Other business – Regulation No. 105 (ADR vehicles)

Proposal for amendments to Regulation No. 105

Submitted by the expert from the International Organization of Motor Vehicle Manufacturers *

Annex 2, Model A, amend the approval mark and the explanatory text below the figure, to read:

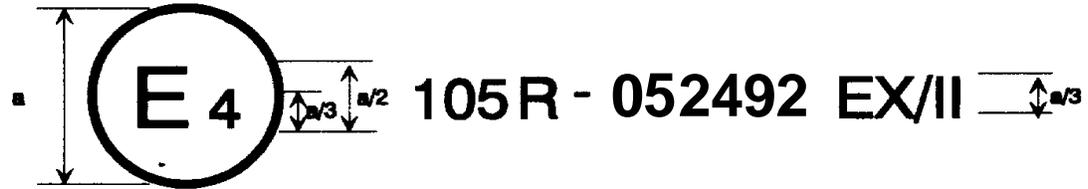
The above approval mark ... under the approval number ~~04~~ 052492 and ...requirements of Regulation No. 105, as amended by the ~~04~~ 05 series of amendments.”

Annex 2, Model B, amend the approval mark and the explanatory text below the figure, to read:

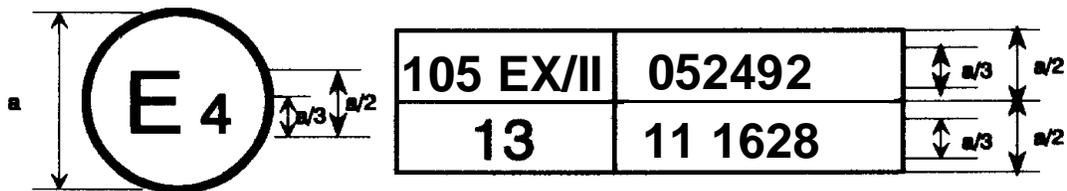
The above approval mark ... , Regulation No. 105, as amended by the ~~04~~ 05 series of amendments, while Regulation No. 13 already included the ~~09~~ 11 series of amendments.”
